SUPPLEMENTAL RESPONSE TO REQUEST FOR ADDITIONAL INFORMATION

APR1400 Design Certification

RAI No.: 69-7994

SRP Section: 03.09.06 – Functional Design Qualification and Inservice Testing Programs for Pumps, Valves, and Dynamic Restraints

Figure 3.9-15 ~~Typical Inservice Testing Connections (1 of 9)~~

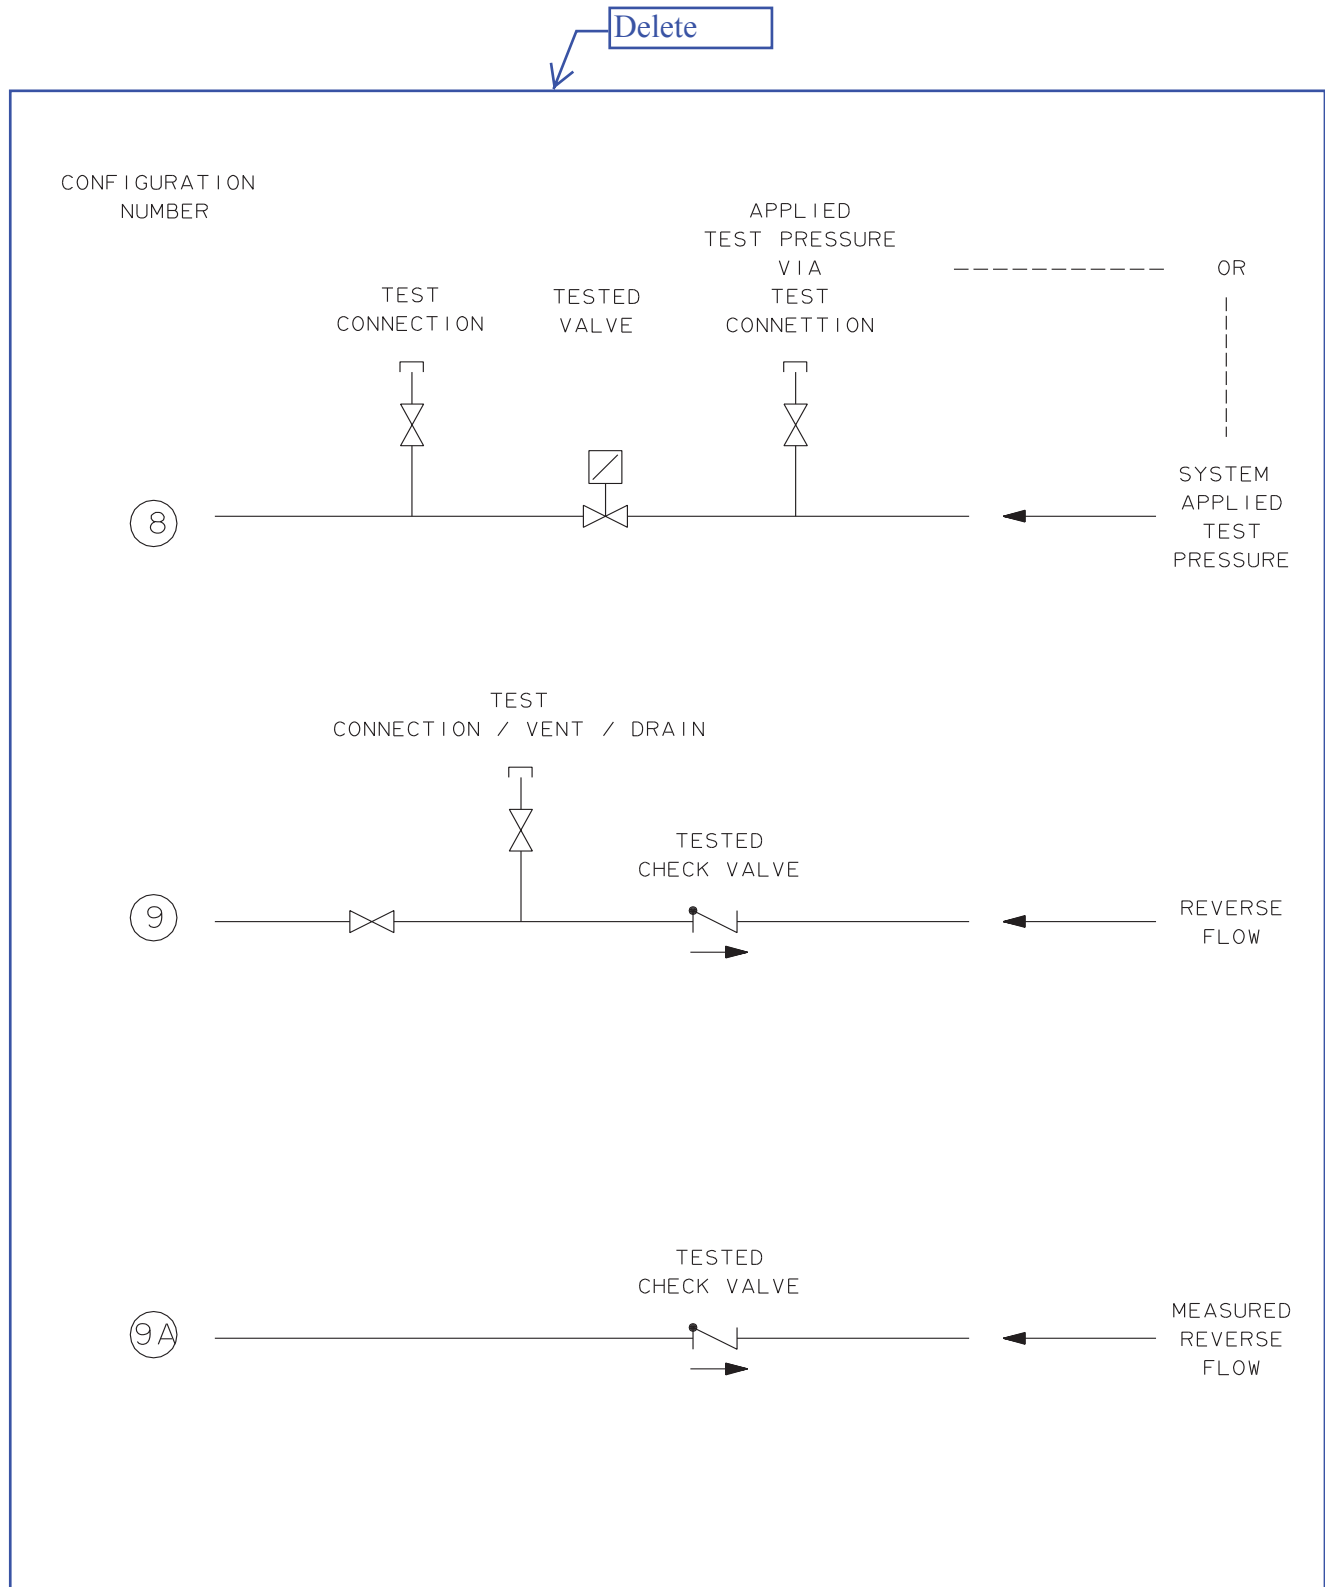
8. Design requirements for the IST program for pumps and valves are listed in Table 3.9-13. Figure 3.9-15, which is referenced in Paragraph (i) on page 3.9-227, shows a typical test configuration for pumps and valves; however, it is not applicable to the APR1400. Therefore, Figure 3.9-15 and the associated parts will be deleted.
9. The Note (23) on page 89 of 95 in Table 3.9-13 will be revised to clarify the position of valves CV-362 and CV-363 during normal operation.
10. Table 3.9-13 will be revised to update all of the pumps and valve information to be consistent with the comments made in the various sections above. In addition, some of the DCD Tier 1 tables will be updated to address the inconsistencies found in the specified valve safety positions.

DCD Tier 2 Figure 3.9-15 will be deleted as indicated in Attachment 4 (Item 8).

Delete

Figure 3.9-15 ~~Typical Inservice Testing Connections (2 of 9)~~

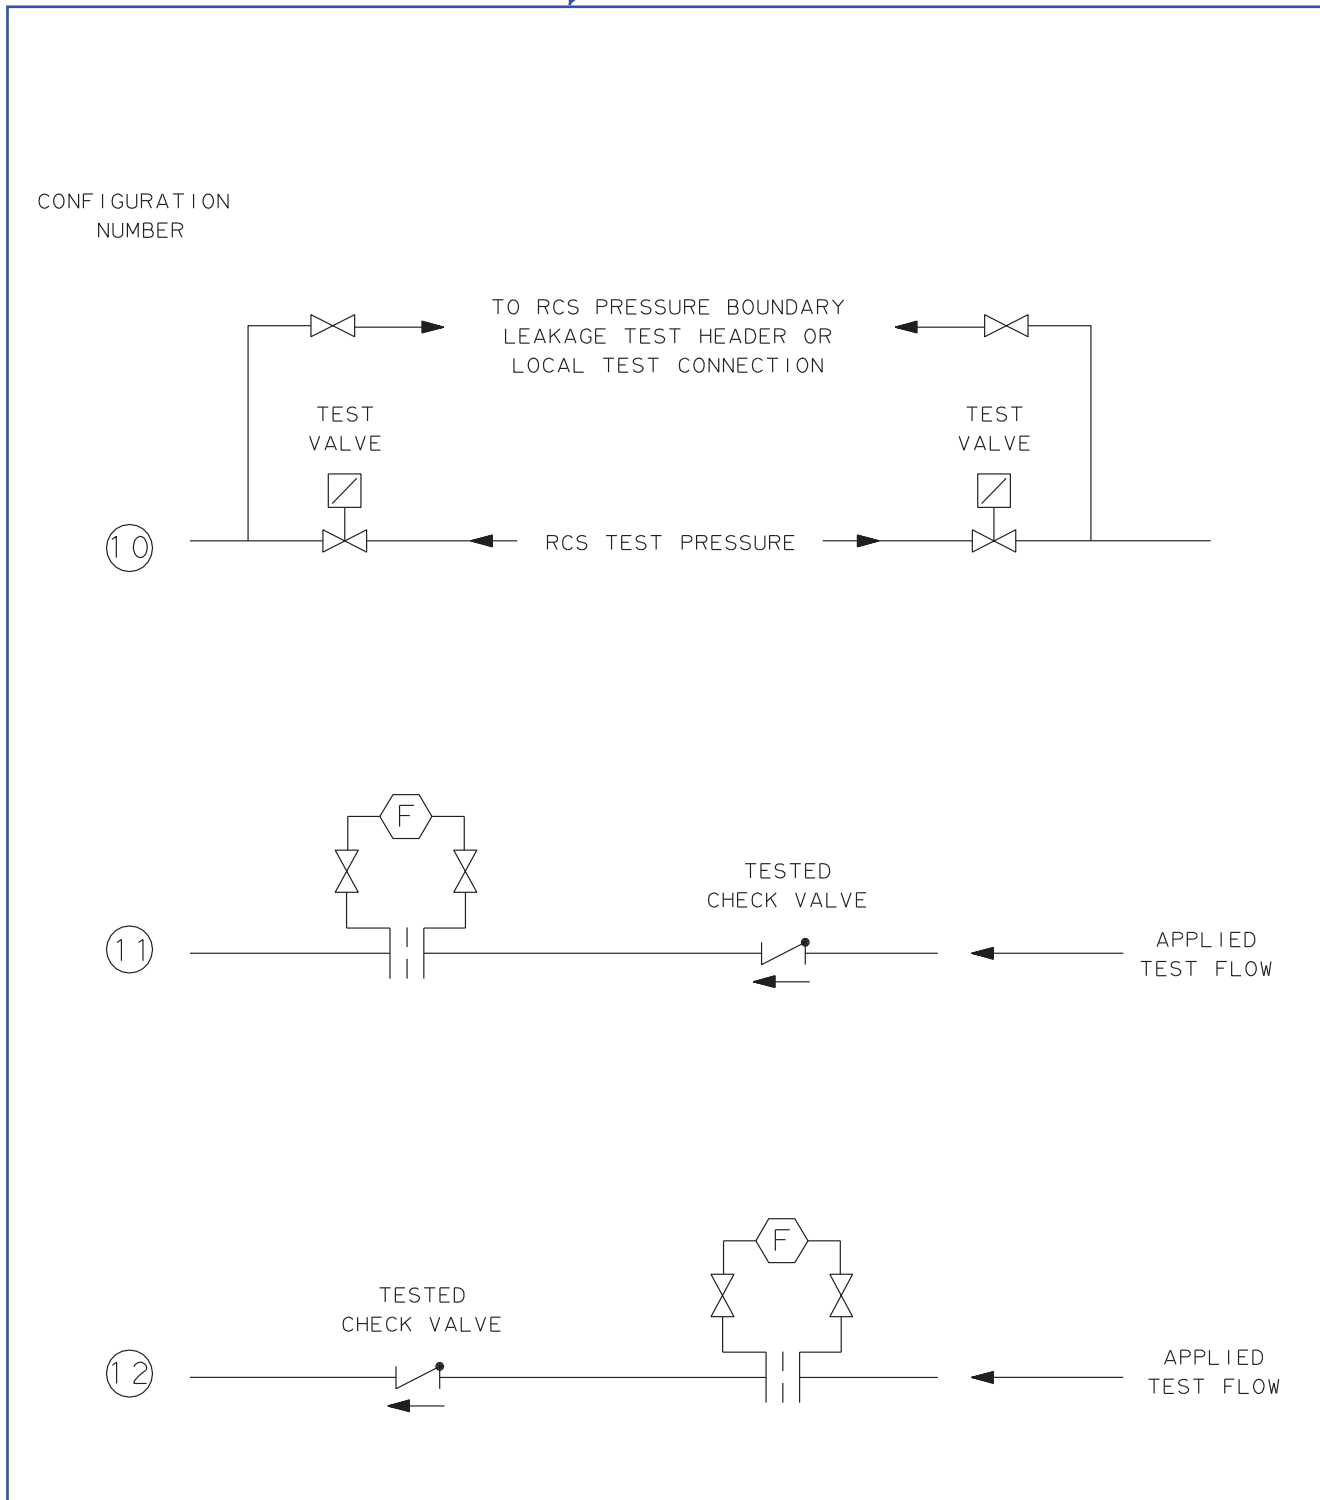
Delete

Figure 3.9-15 ~~Typical Inservice Testing Connections (5 of 9)~~

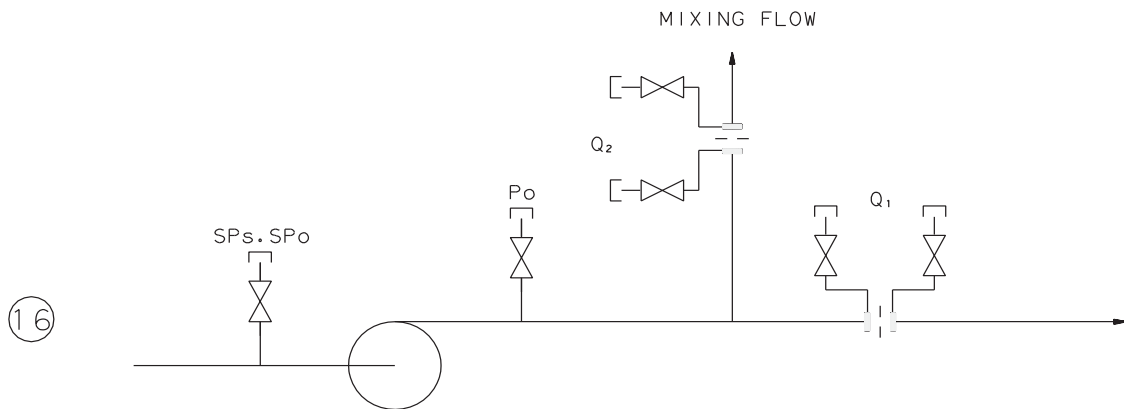
[Delete](#)Figure 3.9-15 ~~Typical Inservice Testing Connections (4 of 9)~~

Figure 3.9-15 ~~Typical Inservice Testing Connections (6 of 9)~~

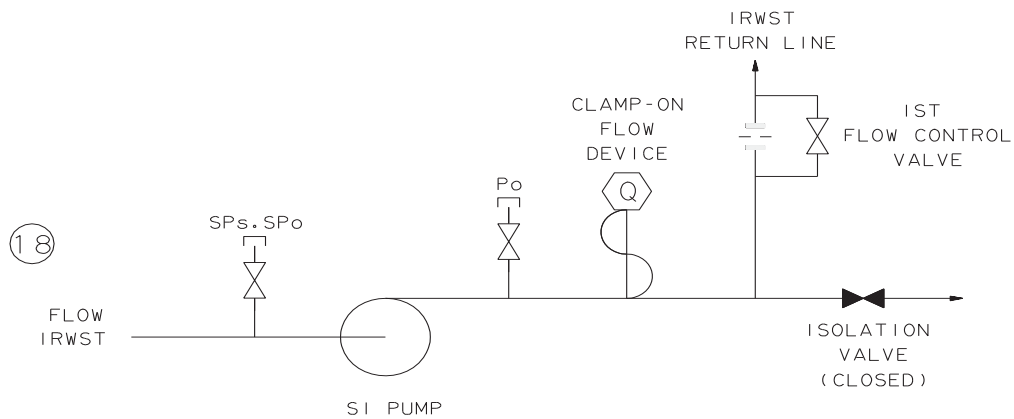
[Delete](#)CONF I G U R A T I O N
N U M B E R

Figure 3.9-15 ~~Typical Inservice Testing Connections (7 of 9)~~

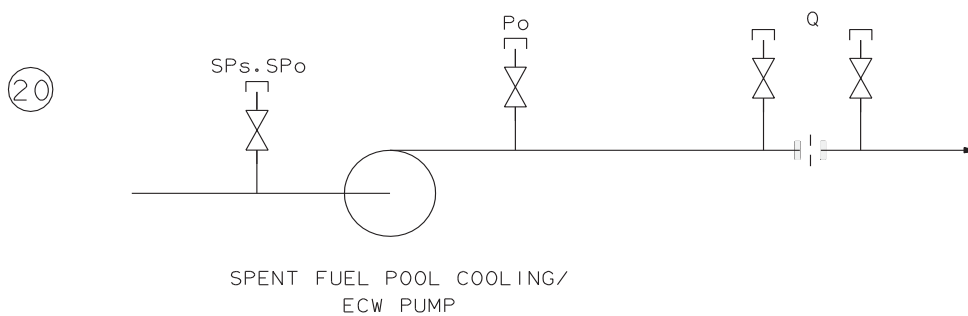
Delete

Figure 3.9-15 ~~Typical Inservice Testing Connections (8 of 9)~~

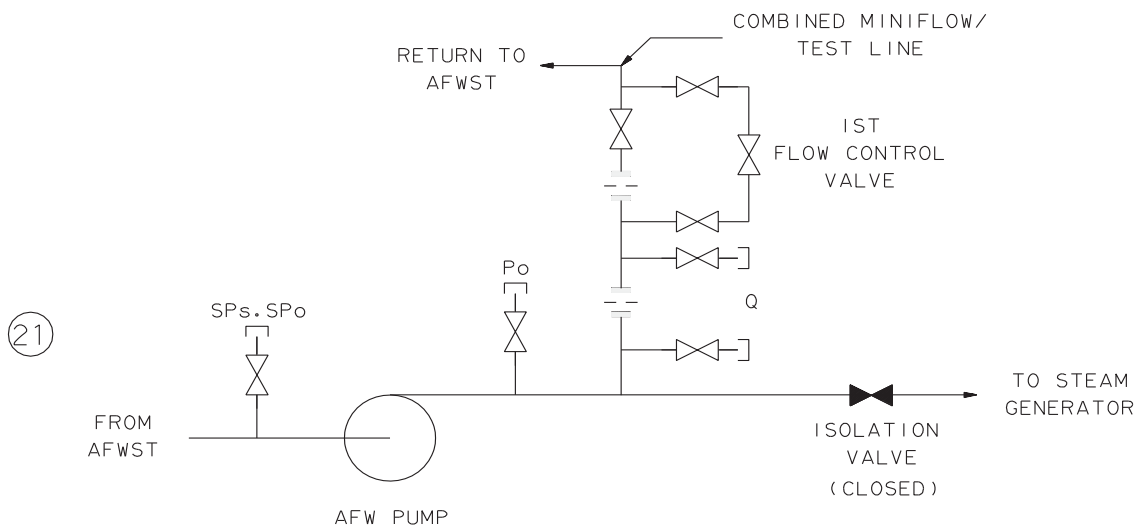
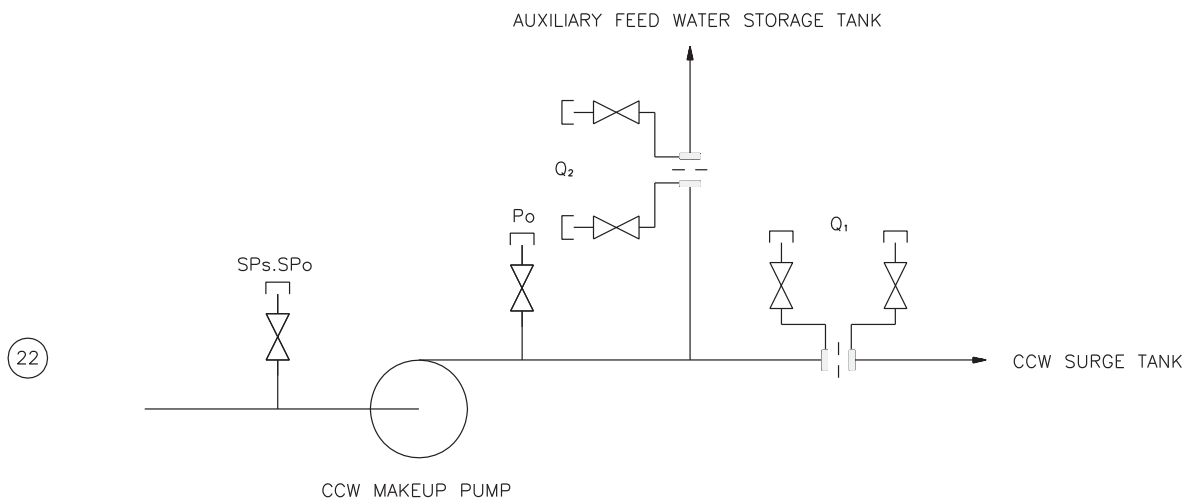
Delete
